3 REVISIONS TO THE DRAFT EIR

This chapter presents specific text changes made to the Draft EIR since its publication and public review. The changes are presented in the order in which they appear in the original Draft EIR and are identified by the Draft EIR page number. The information contained within this chapter clarifies and expands on information in the Draft EIR and does not constitute “significant new information” requiring recirculation. (See Public Resources Code Section 21092.1; CEQA Guidelines Section 15088.5.)

The project consists of the construction and operation of a new 230 kV transmission system with approximately 10.6 miles of new double- circuit 230 kV transmission lines, an expanded substation, a modified substation, a new substation, a new switching station, reconfiguration of four existing 60 kV lines, relocation or extension of two existing 12 kV lines, and upgrades at four remote-end substations and one repeater station.

Revised Figure 3.11-1 Regional Hydrological Setting for the Project Area

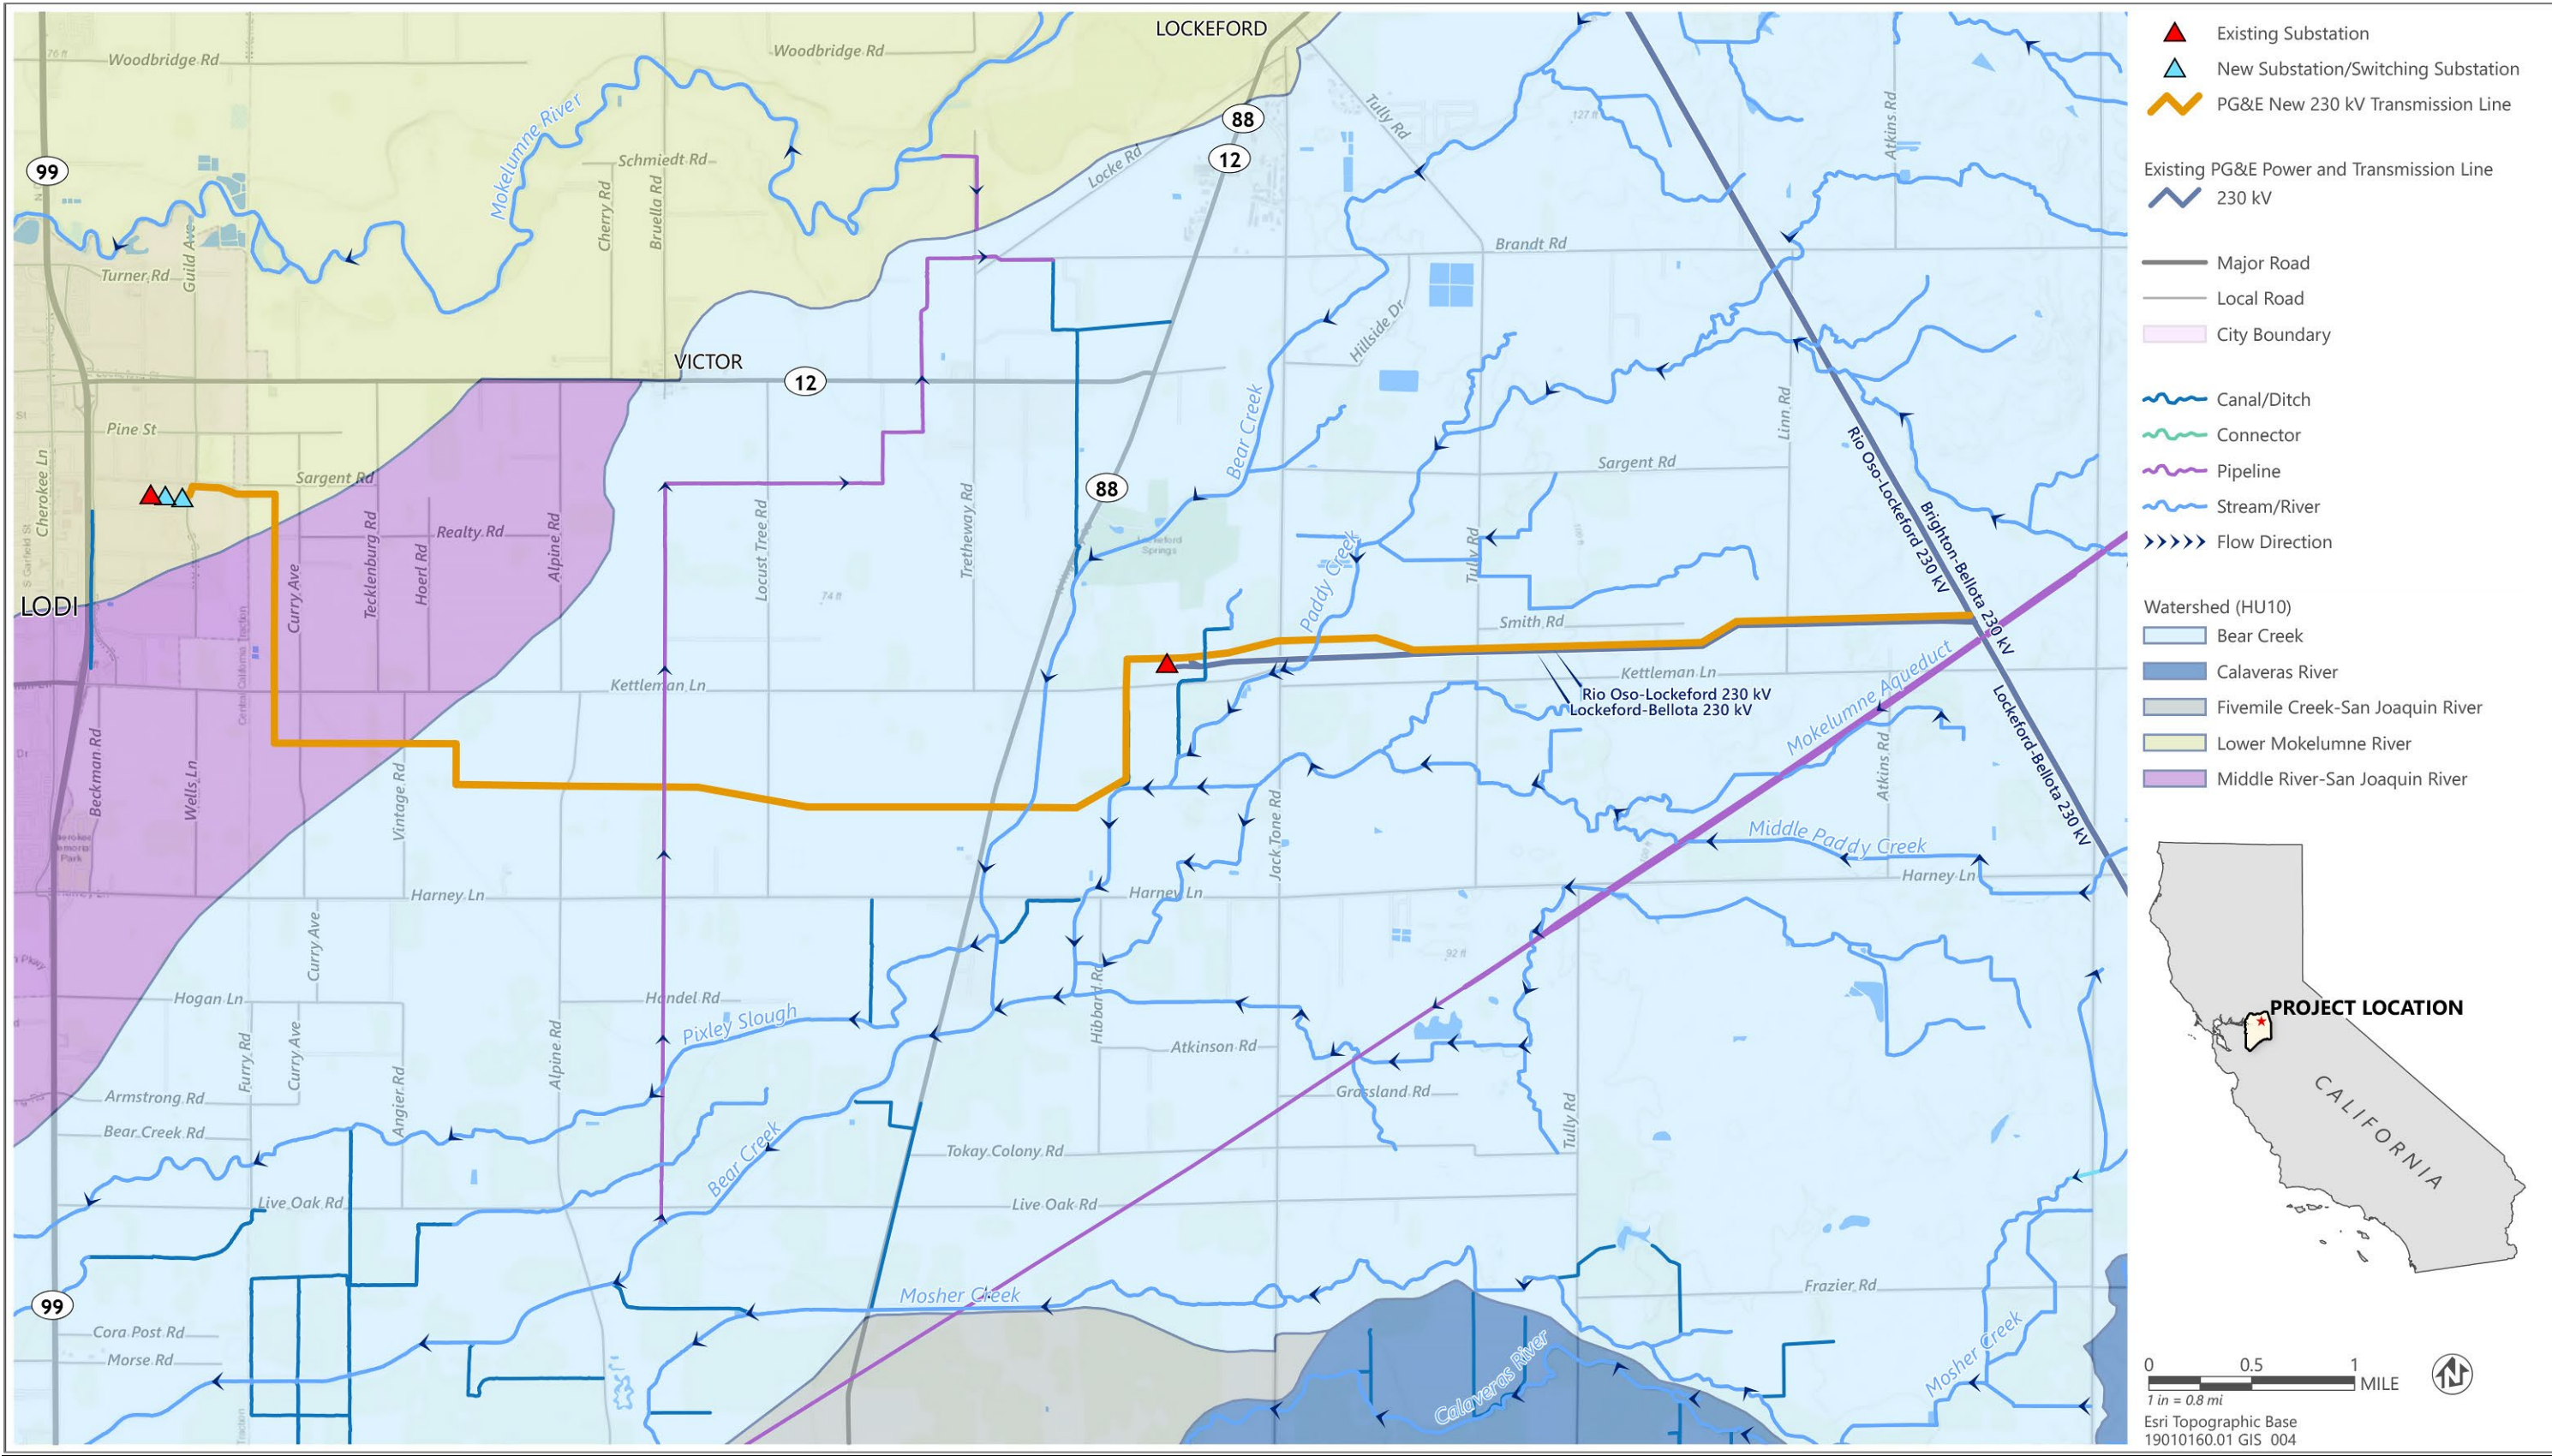
Figure 3.11-1 the Draft EIR is revised as follows to label the Mokelumne Aqueduct in response to Comment A3-1.
